Report of Dam Safety Assessment of Coal Combustion Surface Impoundments
Westar Energy
Tecumseh Energy Center, Clinton, IA

AMEC Project No. 3-2106-0183.0001

November 2010

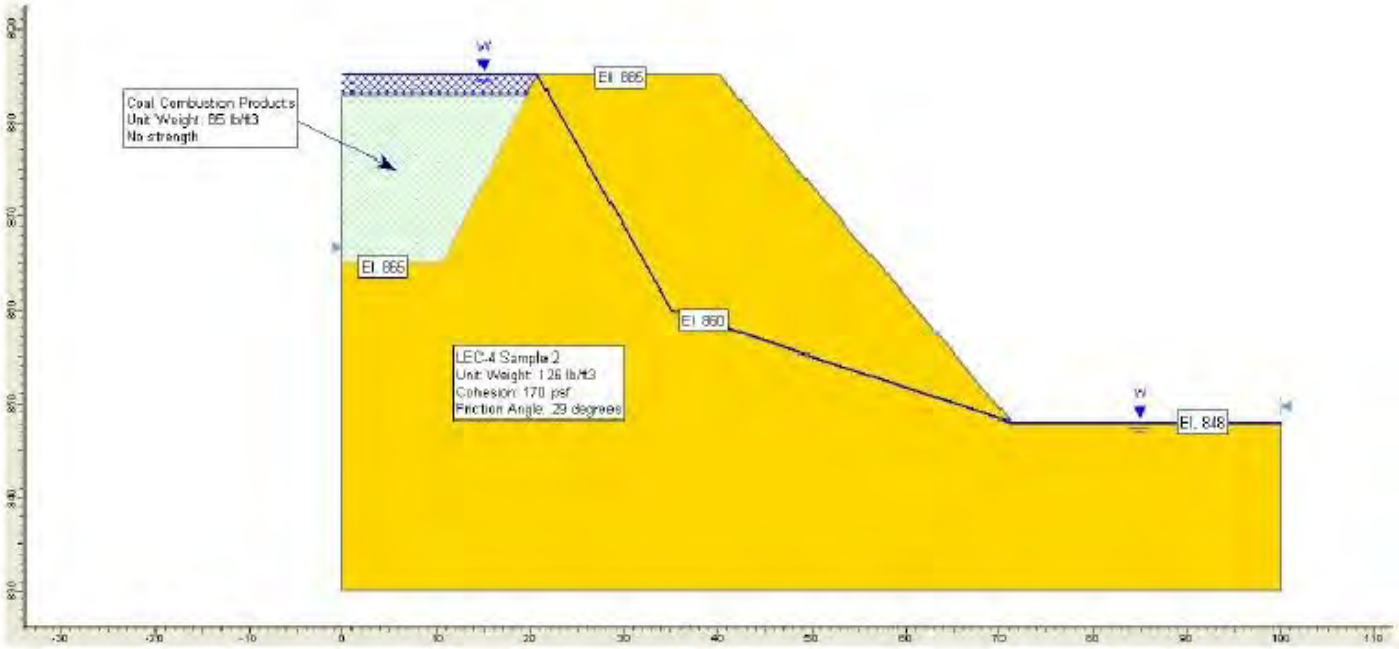
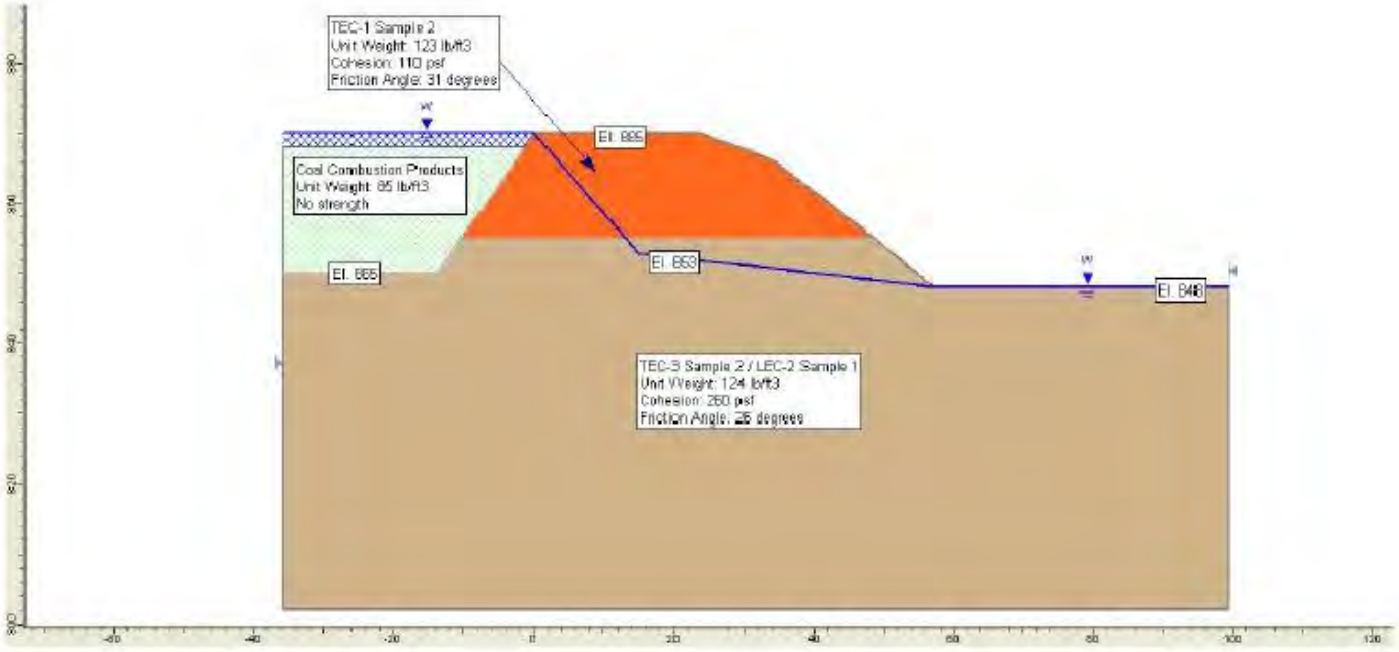
Two cross sections, Section 1 and Section 2, were located to represent critical slope conditions with respect to stability. Figure 9 illustrates the cross section locations as chosen by Golder for the 2009 stability analyses as well as site topographic information provided by Westar Energy. Golder "conservatively assumed that the staging areas were filled with CCP's to an elevation two feet below the berm crests and that ponded water reached the same elevation as the berm crests." Further, based on their visual observation of the drained and cleaned north pool of the Area 1 pond, Golder assumed the depth of the CCP storage facility to be 20 feet. A 0.5 to 1.0 (H:V) slope ratio was chosen for the upstream embankment slopes, apparently based on the same visual assessment by Golder.

A two-dimensional computer program developed by Rocscience Inc. (2009), entitled SLIDE, as used to analyze embankment stability. Golder noted that "Factors of safety for static conditions were computed for circular failure surfaces using Spencer's method for force and moment equilibrium." A seismic coefficient of 0.05, based on a two percent chance of reoccurrence in a 50 year period, and Spencer's method, as described above, were used to compute factors of safety for seismic loading conditions. Table 7 illustrates the computed factors of safety.

Golder noted that, "Based on the factors of safety computed using SLIDE, some portions of the CCP storage facilities at TEC [1] may be only stable under static conditions and may become unstable during a seismic event or if loaded beyond the assumed conditions." Computed static and seismic factors of safety for Section1 do not meet minimum acceptable factor of safety criteria. The stability of Section 2 was found to be acceptable, with factors of safety exceeding accepted minimums.

Following the initial stability calculations, Golder performed additional analysis and determined that acceptable factors of safety would be obtained for Section 1 if the existing slope was decreased (flattened), specifically to 1.7:1 (H:V). Calculated factor of safety values for the flattened slope section were determined to be 1.5 and 1.3 for static and seismic conditions, respectively. Figure 11 illustrates the boundaries of the over steep slope area of the Area 1 Pond's north embankment that would require repair.

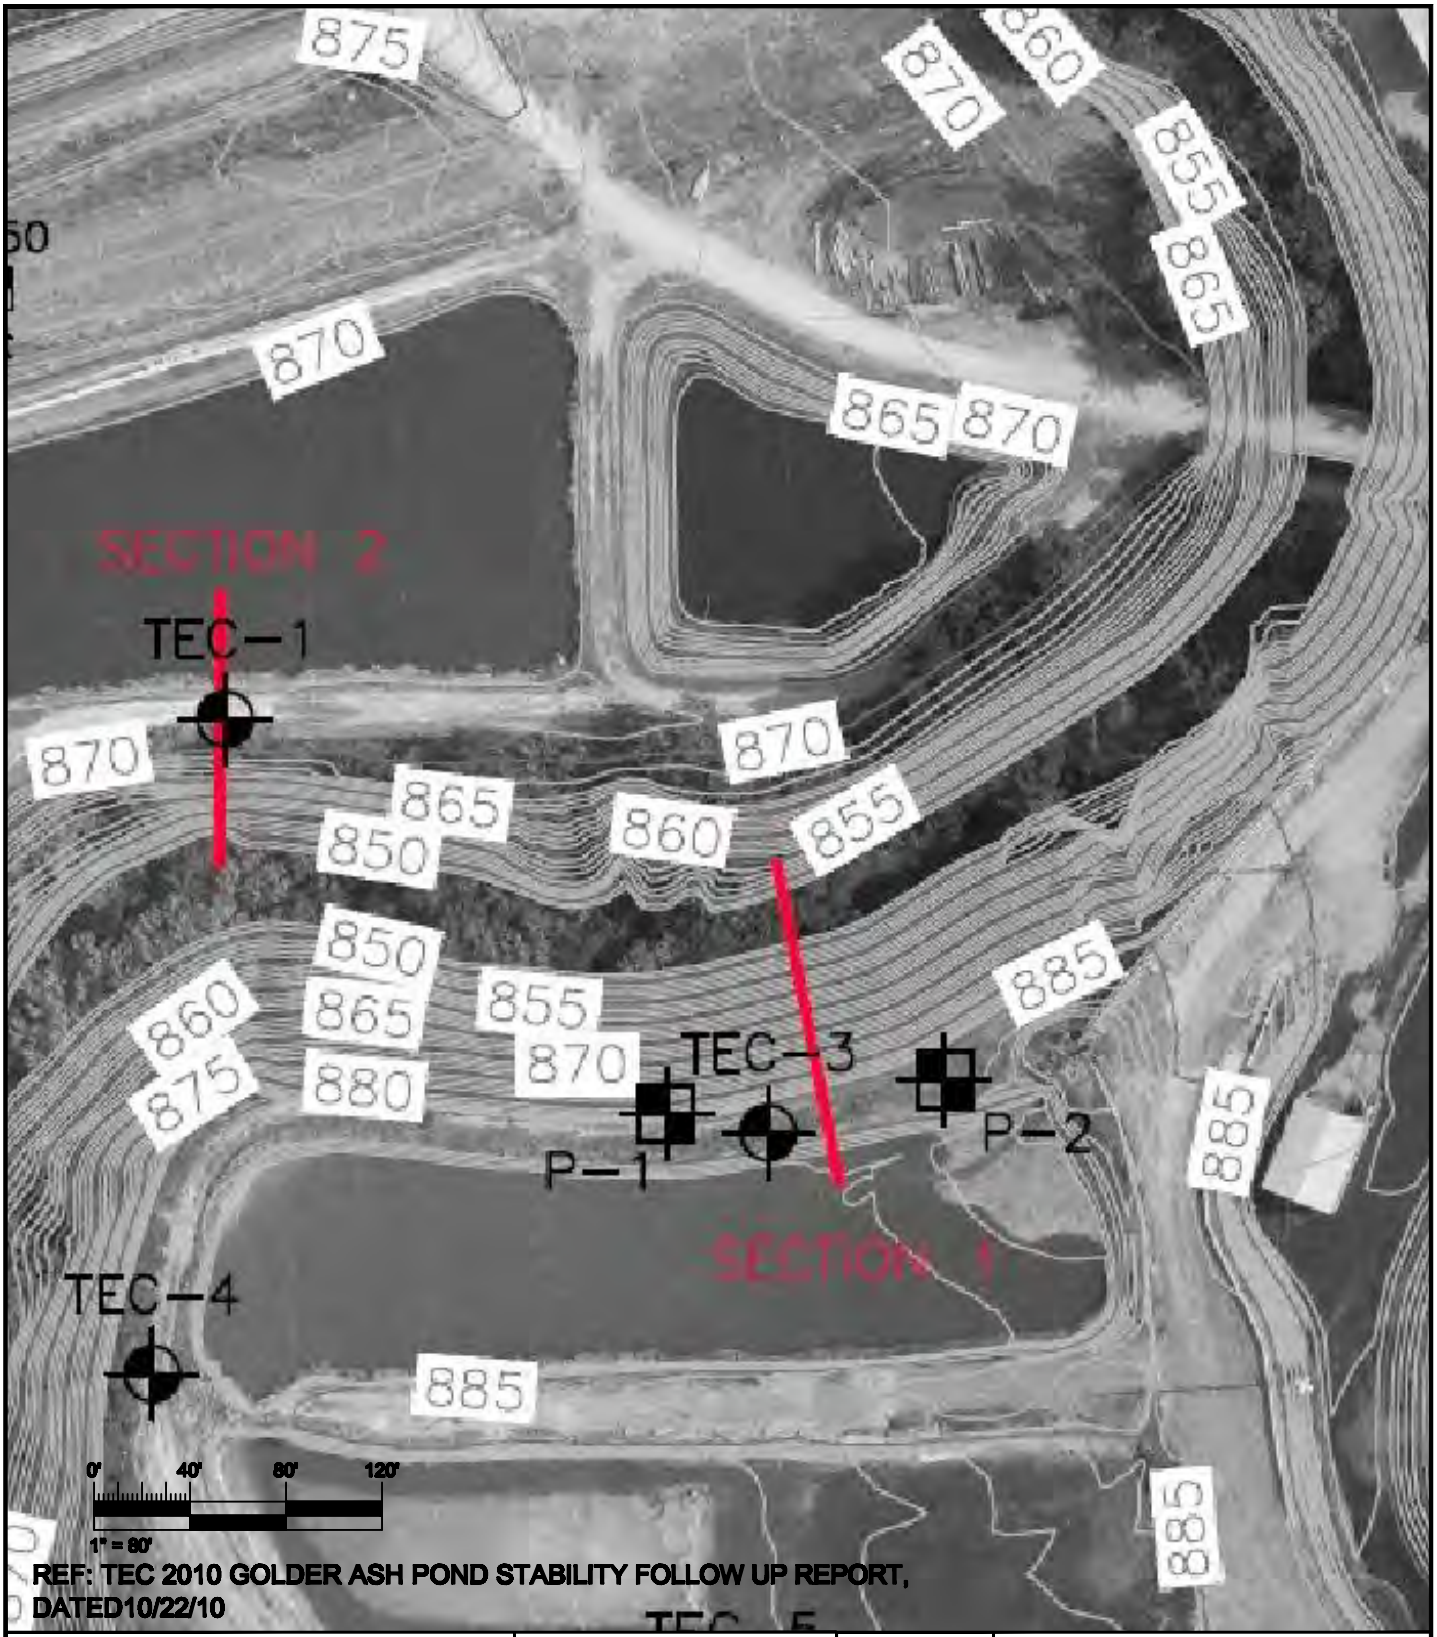
The report notes that for "purposes of the stability analyses, Golder represented distinct soil layers and assigned engineering parameters based on proximity to sampling locations, field soil classification and laboratory test data." Figure 10 illustrates the 2009 stability analyses Section 1 (Area 1 Pond) and Section 2 (Area 2 Pond), including assigned engineering parameters. Unit weights were assigned to each soil layer based on "density testing of undisturbed soil samples collected at TEC." The boring identification appears to have been inadvertently left out of the document. Further, the report noted with regard to parameters,

Groundwater was reportedly not observed in any boreholes near Section 1; therefore, Golder assumed a groundwater surface located just below the bottom of borehole TEC-3, which is located closest to Section 1. Therefore, the groundwater elevation at Section 1 was identified as "860 feet above mean sea level, 7 feet higher that the groundwater at TEC-1." The phreatic surface was assumed to be a straight line between the "upstream edge of the berm crest and the assumed static groundwater level" at the borehole. Groundwater was located at 853 feet above mean sea level at boring TEC-1. Therefore, since TEC-1 is near Section 2, "the phreatic surface in the center of the berm was set to that elevation." The phreatic surface alignment in Section 2 was located as described for Section 1.

PROJECT: ASSESSMENT OF DAM SAFETY OF COAL COMBUSTION SURFACE IMPOUNDMENTS	DWN BY: CAE	DATUM:	DATE: 11/22/10
TITLE: WESTAR ENERGY TECUMSEH ENERGY CENTER, TECUMSEH, KS 2010 STABILITY ANALYSIS CROSS SECTION	CHK'D BY: MOS	REV. NO.:	PROJECT NO: 3-2106-0183.0001
	PROJECTION:	SCALE: AS SHOWN	FIGURE No. 13

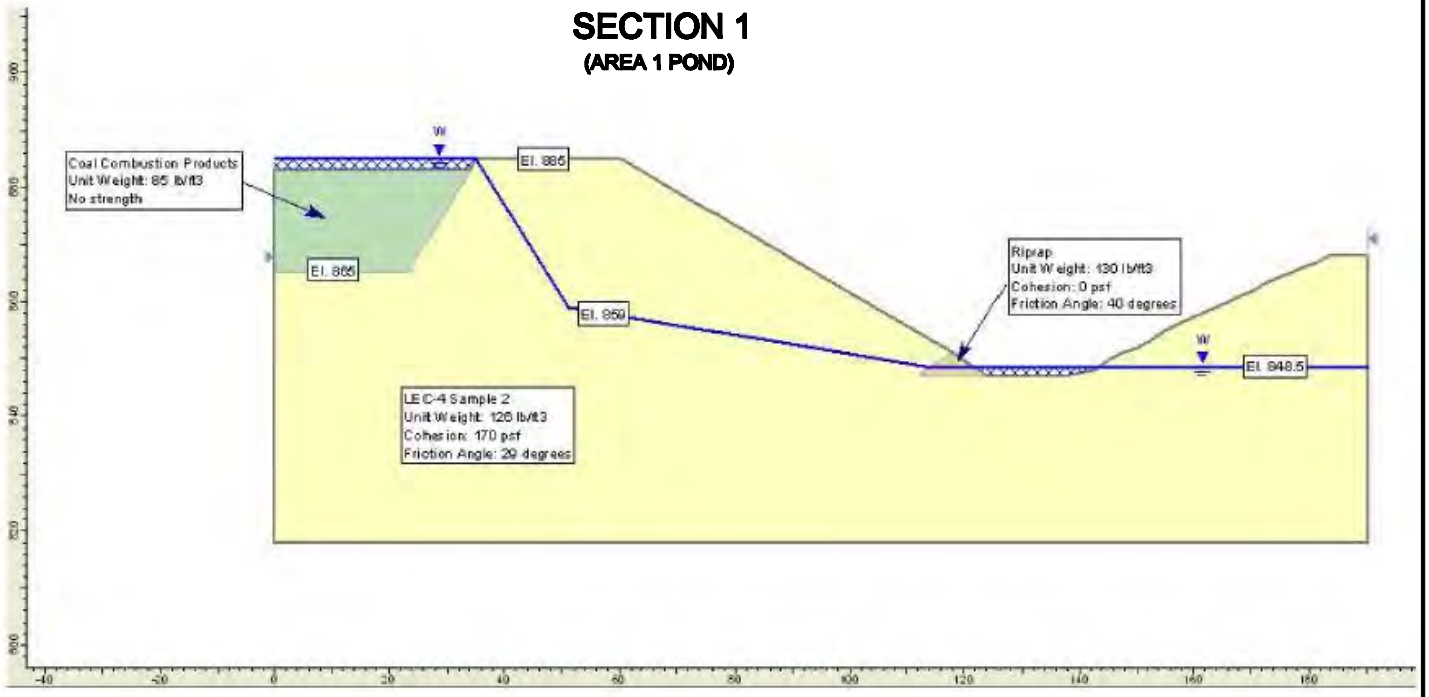
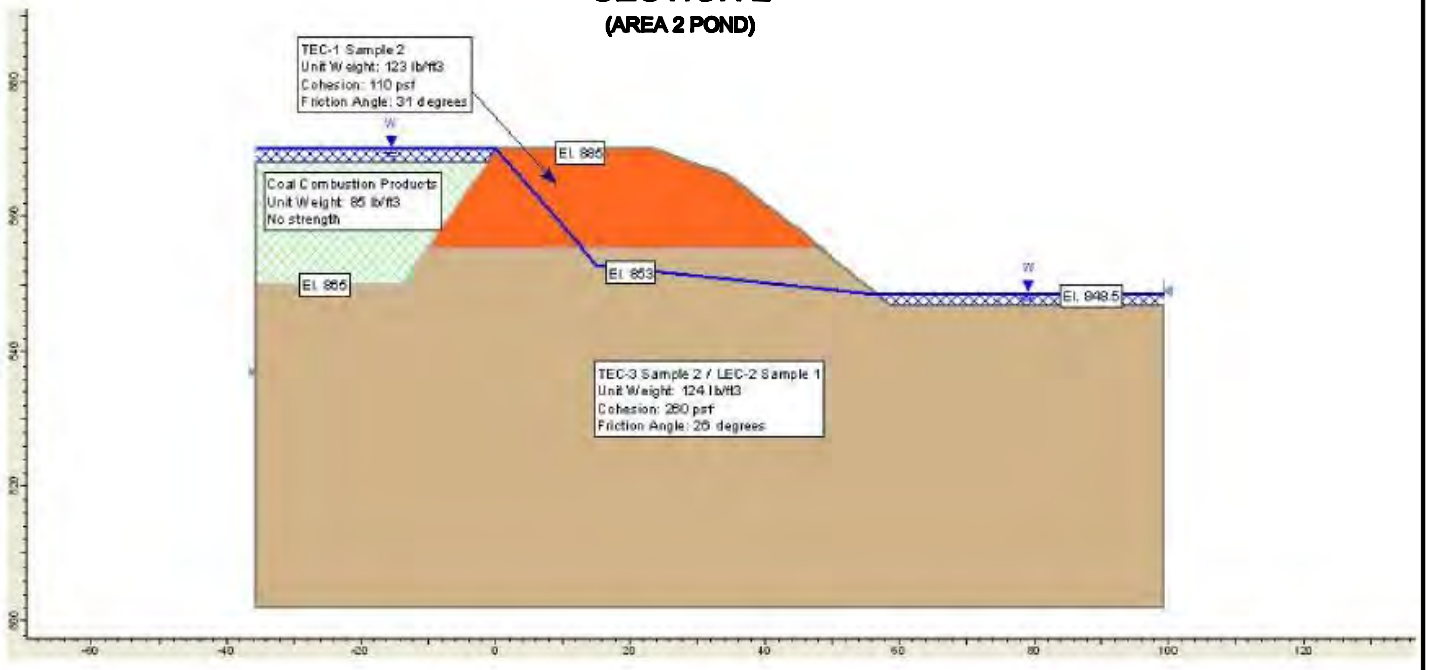
Although several borings had been advanced for the 2009 evaluation of berm stability, two additional borings, P-1 and P-2, were advanced in the northern crest of the Area 1 Pond for the 2010 study, as shown on Figure 12. Piezometers were installed in these borings at locations designed by Golder and Westar, "to better define piezometric levels" in the area. Figure 12 illustrates the piezometer locations and information specific to these piezometers is provided in Section 3.5.2.

Golder addressed phreatic surfaces for Section 1 by determining the groundwater elevation in the piezometers, P-1 and P-2, five months following installation. The observed elevation was noted as 859 feet above mean sea level. It was noted in the report that Golder assumed the phreatic surface would consist of two surfaces;

The same stability cross section locations were used for the 2010 evaluation; however, the downstream slope of Section 1 was flattened to 1.7: (H:V) as indicated by the additional analysis that followed the 2009 evaluation. Figure 12 illustrates the uniformly regraded north embankment slope of the Area 1 Pond. Figure 13 illustrates the 2010 stability analyses Section 1 (Area 1 Pond) and Section 2 (Area 2 Pond), including assigned engineering parameters. The engineering parameters for the 2010 study included an entry for riprap material, with parameter values as shown on Figure 13, due to the fact that the proposed regrade included riprap placement at the base of the slope. Table 8 illustrates the computed factors of safety resulting from the flattened slope and riprap addition.

Golder noted that the results indicate that the Area 1 and Area 2 Ponds should "remain stable under maximum anticipated loading conditions."

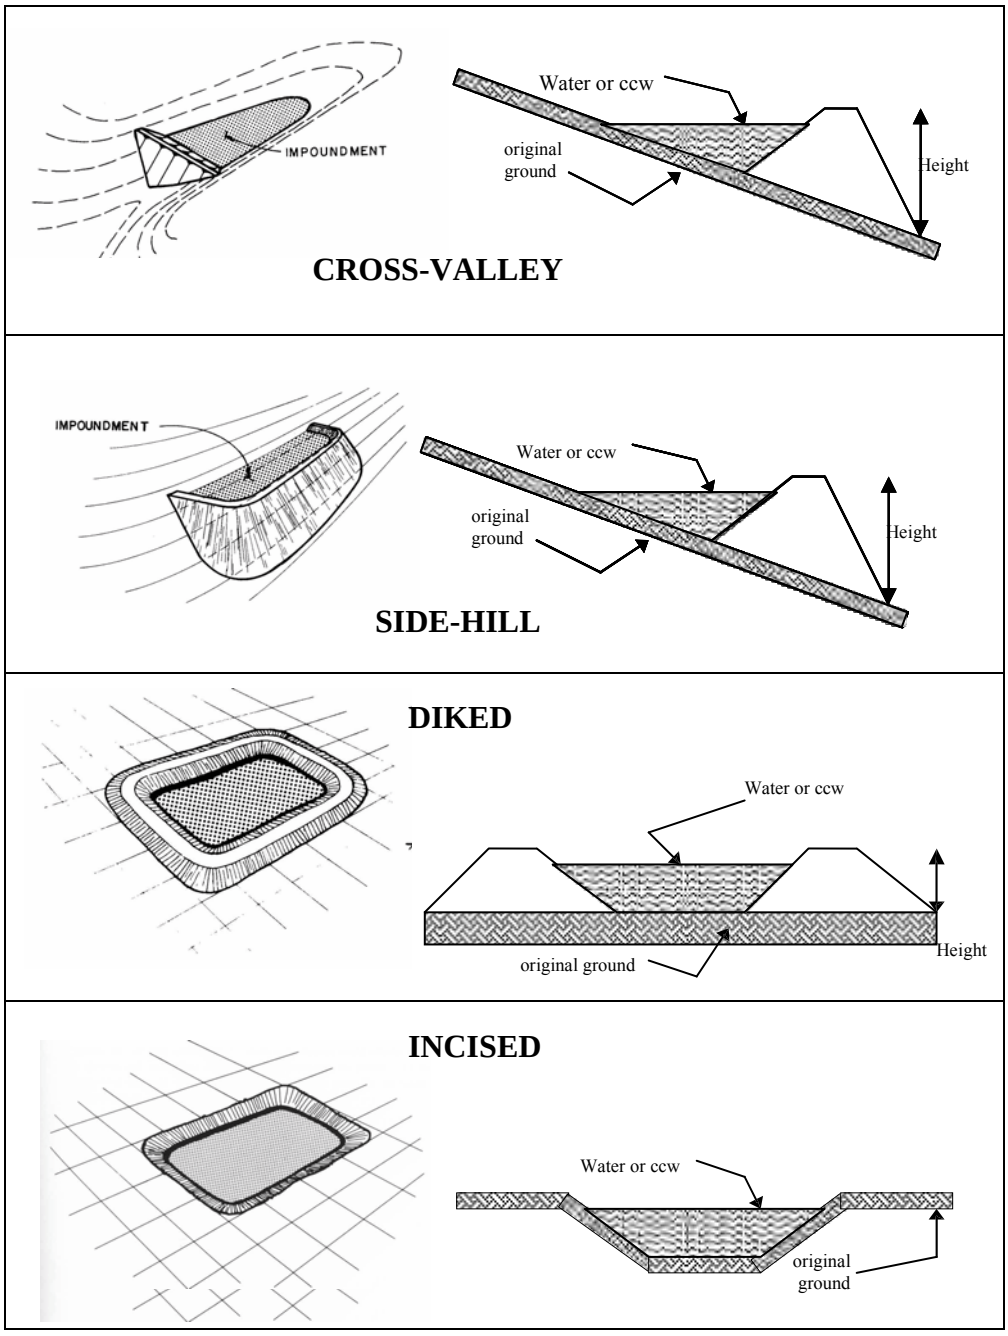
Inspection Issue #	Comments
1.	Westar does not formally inspect ponds. Westar has plans to institute formal inspection program.
2.	High weir flow 6" (882.5 ft.) Low weir flow 3" (882.25 ft.)
5.	Topography and recent Golder Stability Report show minimum crest elevation between 885 ft. and 885.5 ft.
6.	None - but temporarily installed for Golder's Stability Analysis/Geotechnical Investigation
7.	Just finished bank repair (north) of Ash Pond 1 (Main) 2009 Report/DWGs and 2010 Follow up
8.	Majority of pond is incised, no information provided regarding preparation of any constructed embankment section.
9.	Trees on embankment 18" - 24" diameter
17. – 19. & 21 - 23.	Difficult to determine due to heavy vegetation on embankment and toe of slope.

Embankment Height 36.5 feet Embankment Material Silty clay
Pool Area 2 acres Liner No
Current Freeboard 3 feet Liner Permeability N/A
